TO: Keith Fronczak, Boulder Associates
FROM: Stacey Nerger, Senior Planner
DATE: October 30, 2024
SUBJECT: Crown Point Filing No. 1 Amendment 30 Lot 1– Site Plan Review Comments 03

SITE PLAN

ADVENTHEALTH PARKER FACILITY EXPANSION

DESCRIPTION	DATE
1ST SUBMITTAL	06/03/2024
2ND SUBMITTAL	08/16/2024
3RD SUBMITTAL	10/10/2024

SHEET TITLE
COVER SHEET

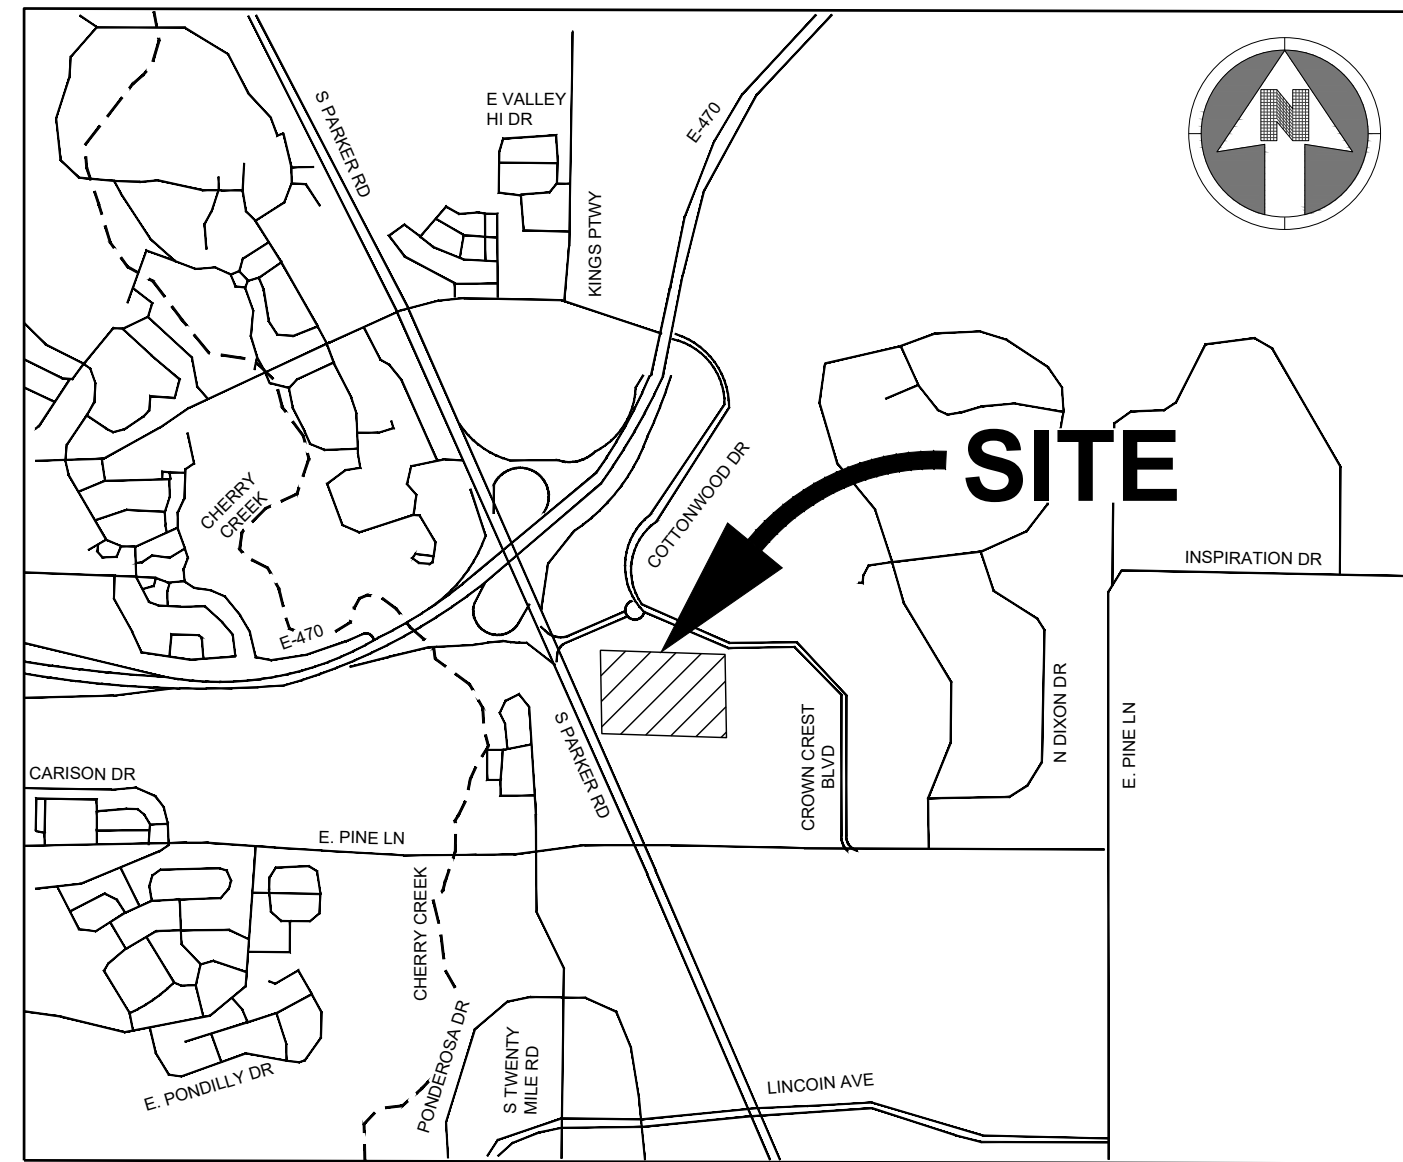
Same with this area. Is the proposed hardscape an addition to the existing for a total of 788,457 SF. Need to have accurate numbers that can be used for any future additions or changes.

Is this correct? This site plan proposes to remove landscaped area, is there additional landscaping beyond the 385,781 SF proposed?

The Crown Point PD requires a 30' setback between PA boundaries and buildings. Please amend this building to meet the required setbacks.

Please add back in the south property line and setback requirement. Pursuant to the Crown Point PD this setback is 30'

4 BOLLARD EXAMPLE IMAGE - LOADING DOCK AND SHED (COLOR TBD)
09 of 25 NO SCALE

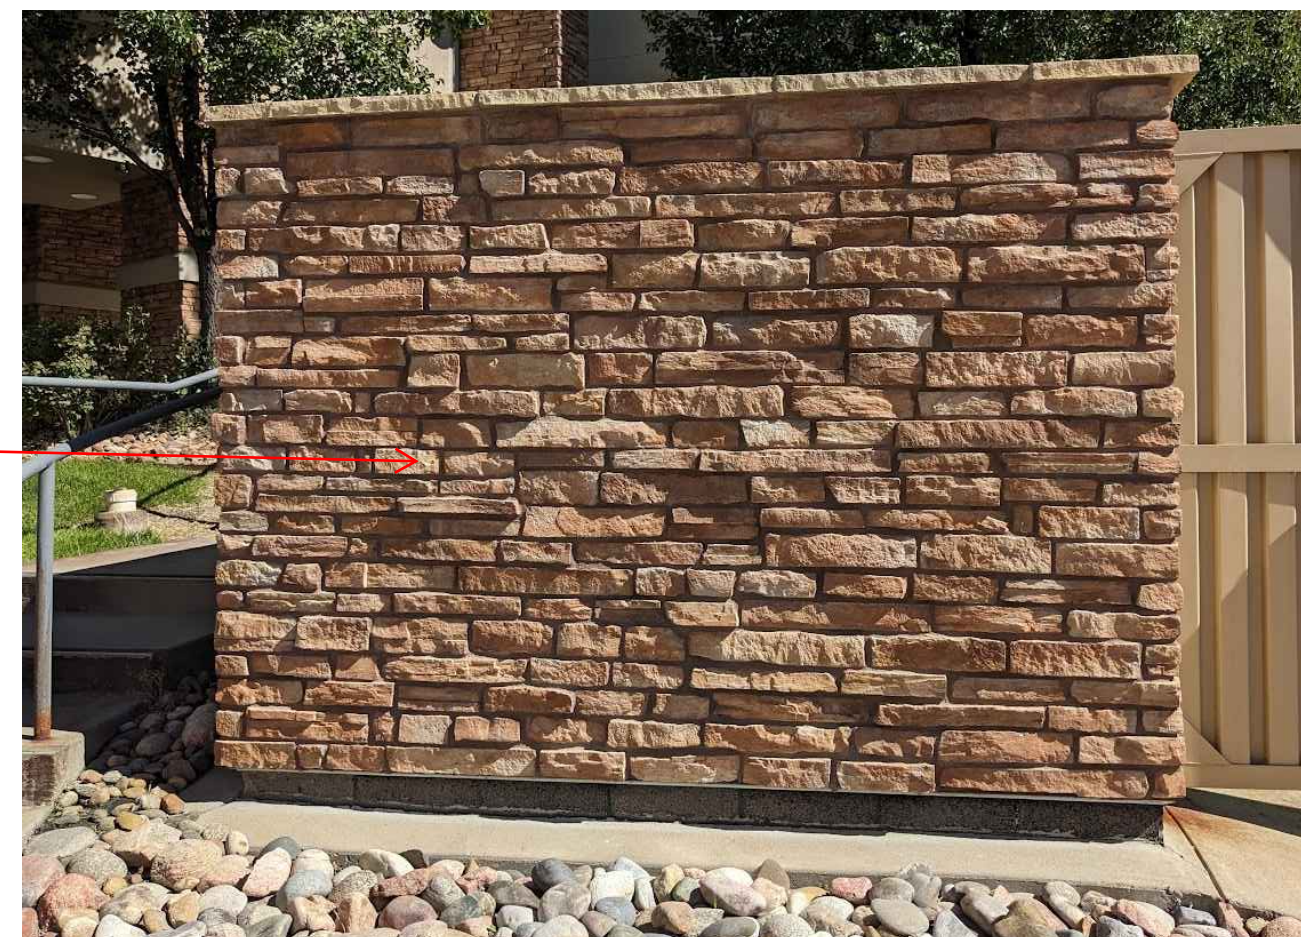
Please label these to match the name on the previous pages. Is this the Pipe Bollard?

5 BOLLARD EXAMPLE IMAGE - ED ENTRY - BLACK FINISH
09 of 25 NO SCALE

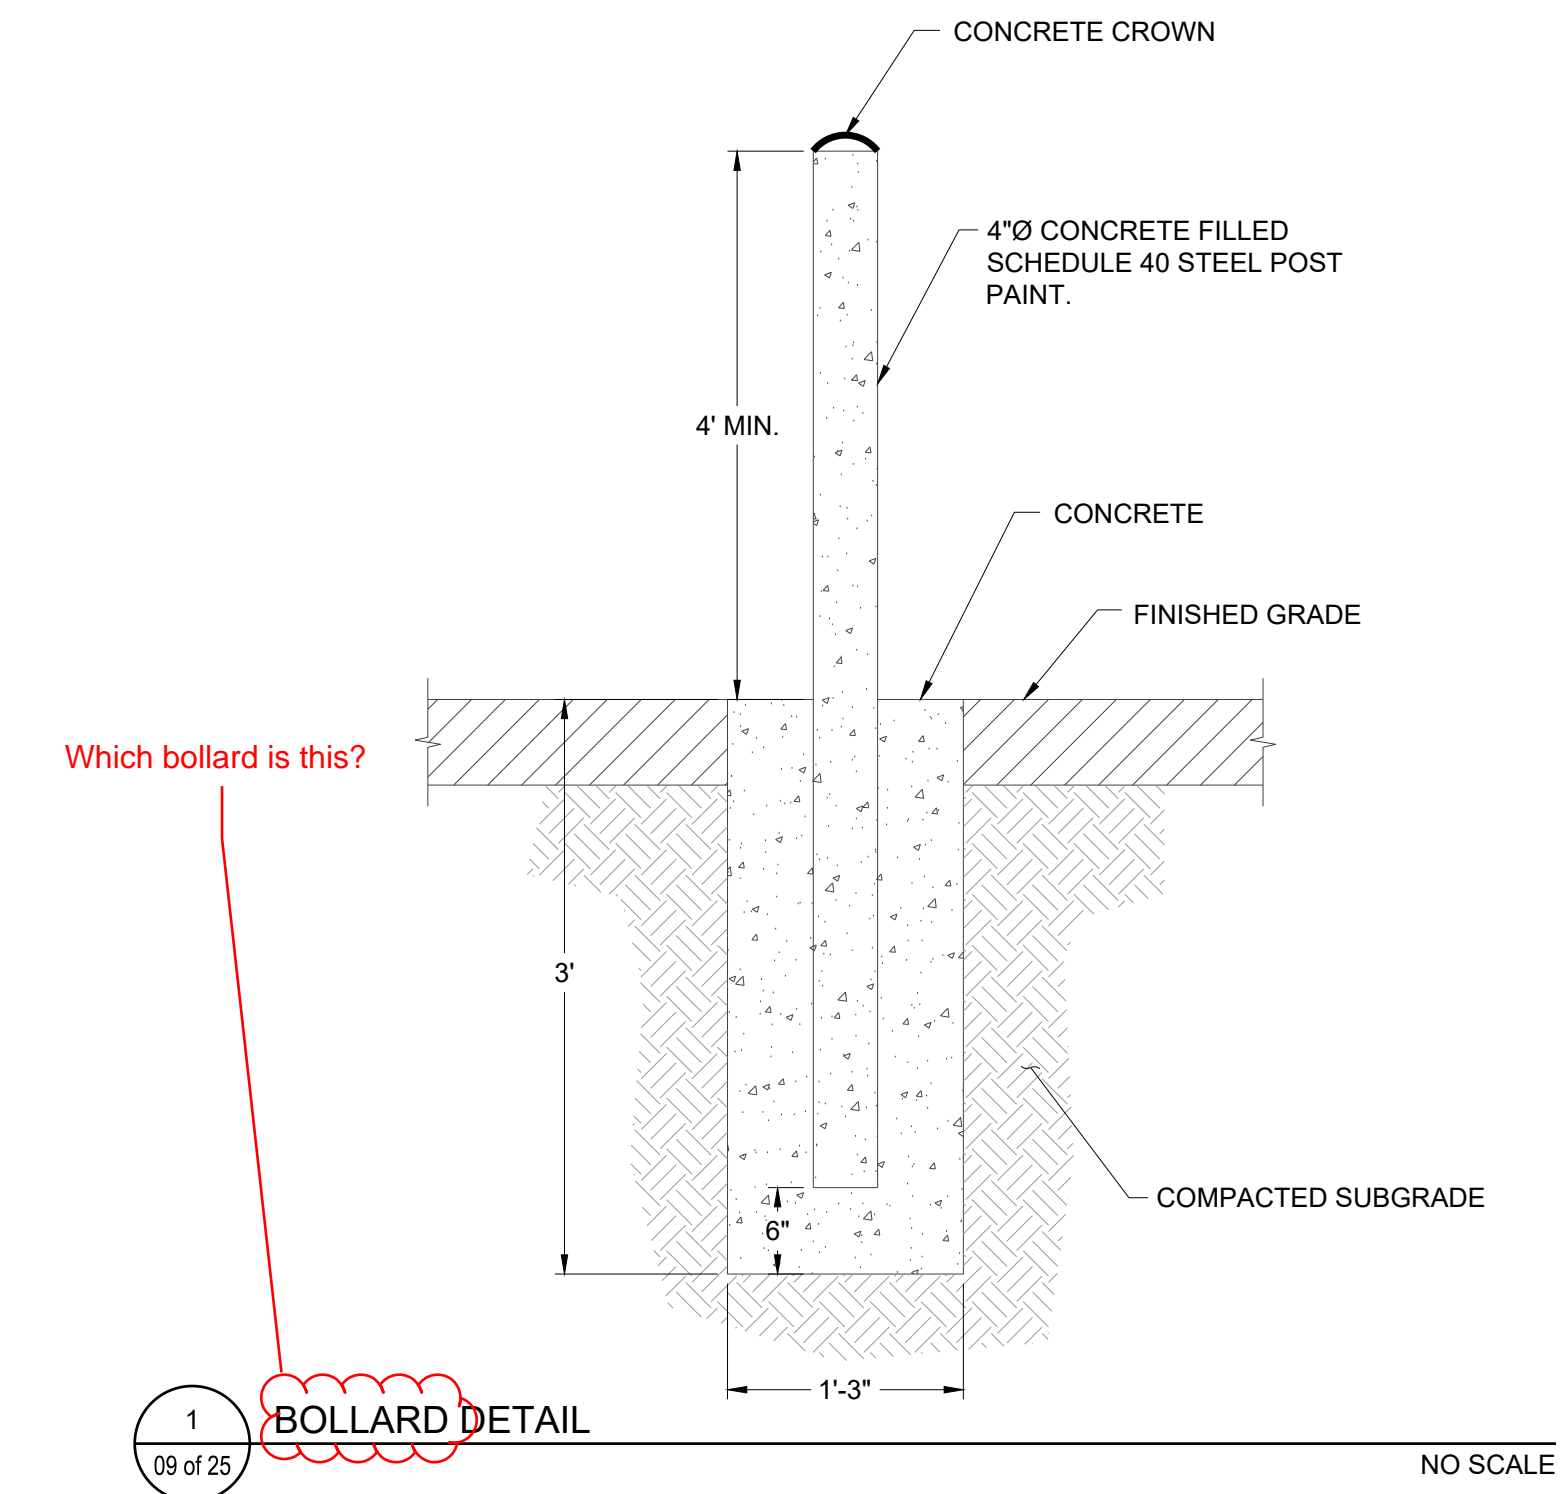
Please label these to match the name on the previous pages. Is this the Decorative Bollard?

Please label materials and colors.

6 RETAINING WALL EXAMPLE IMAGE
09 of 25 NO SCALE

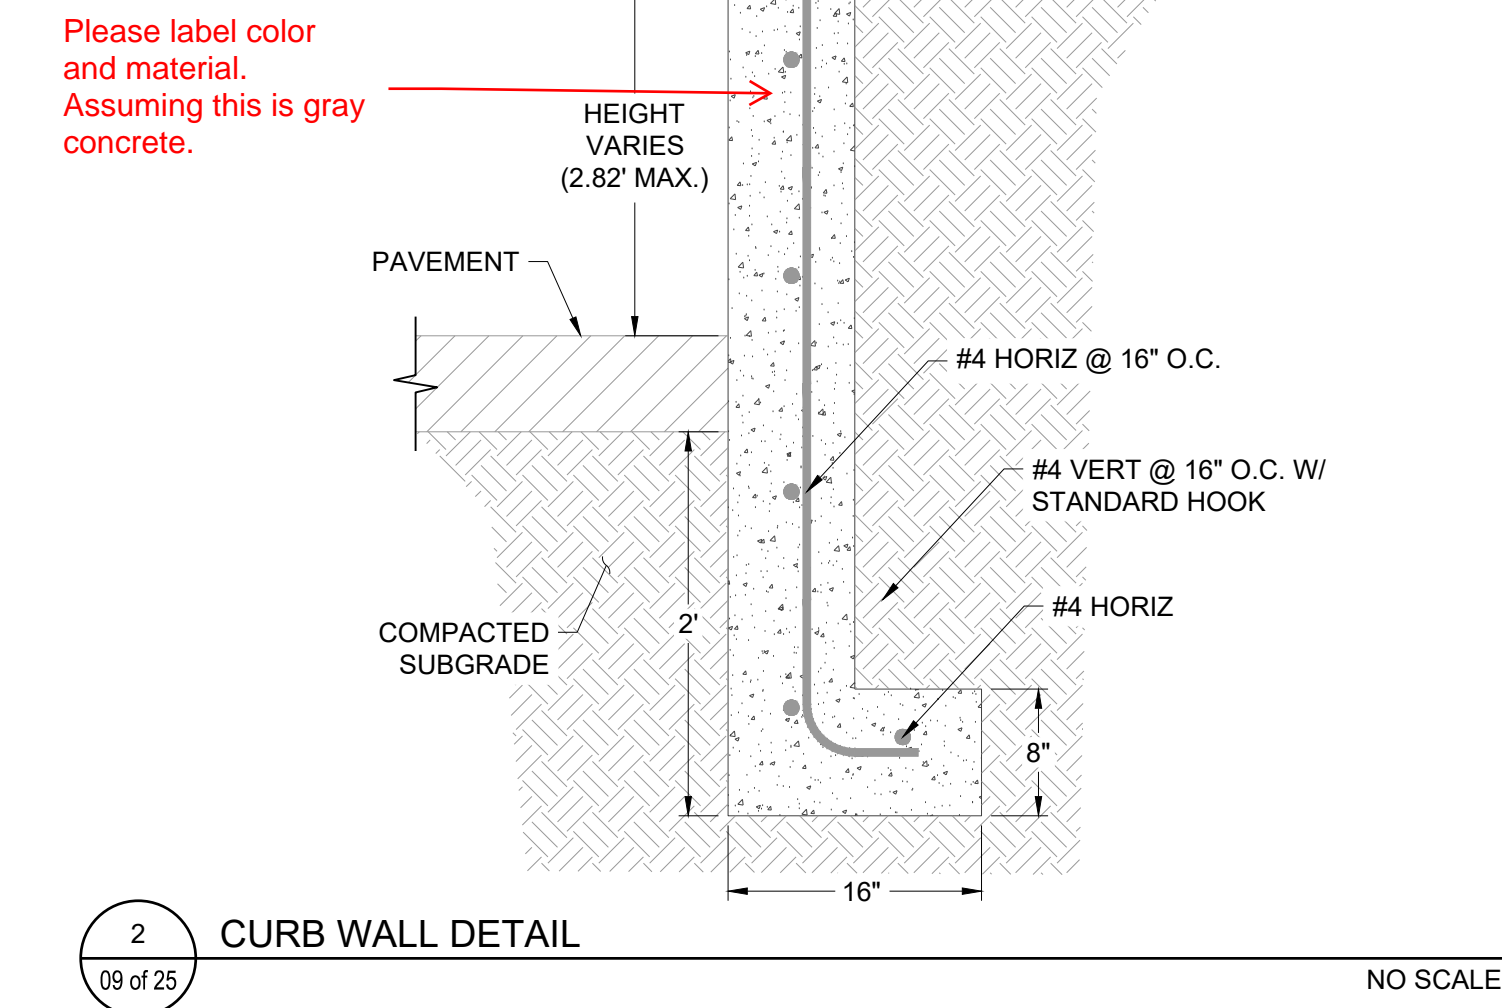
Which bollard is this?

2 CURB WALL EXAMPLE IMAGE
09 of 25 NO SCALE

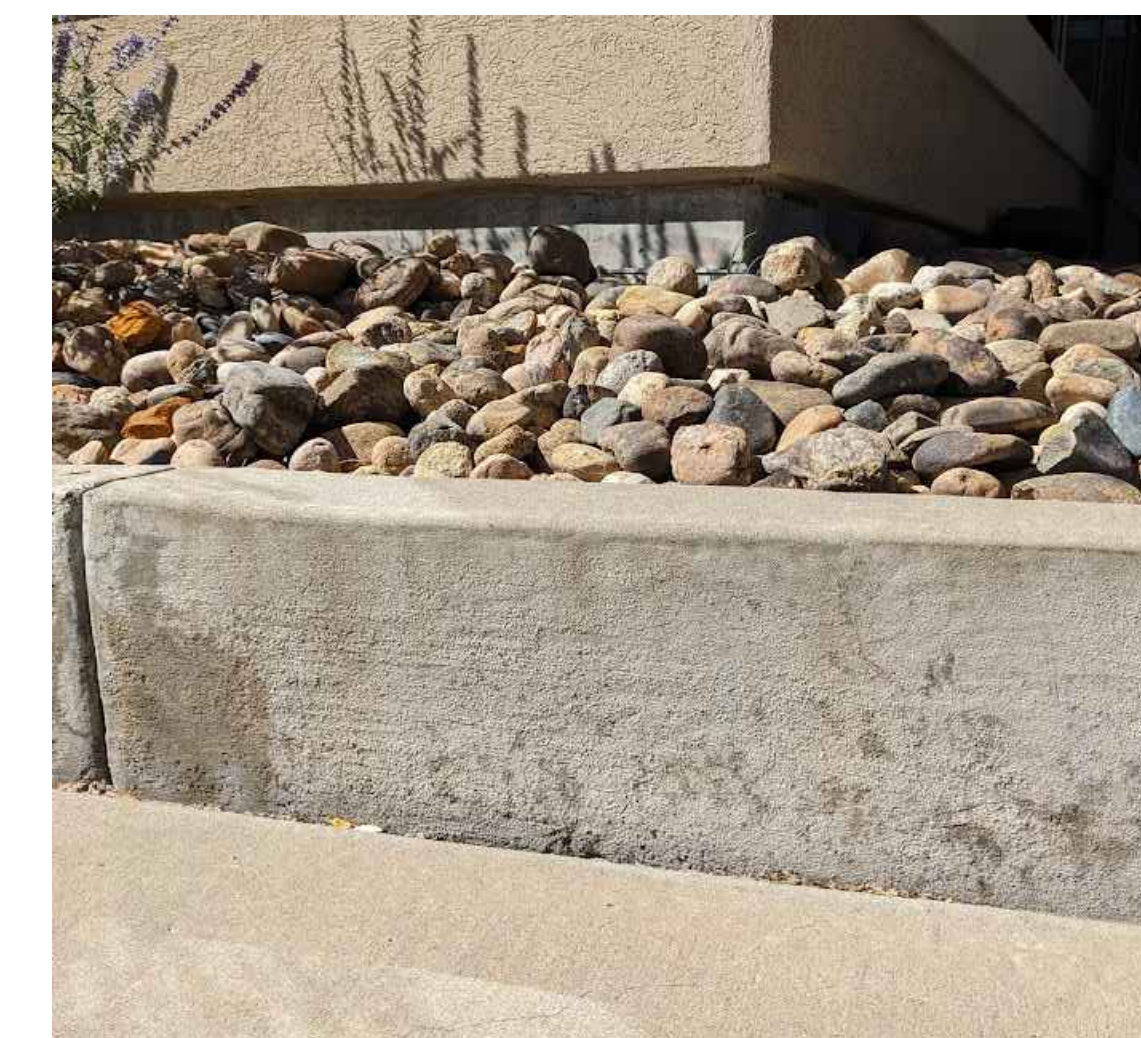
Please label color and material. Assuming this is gray concrete.
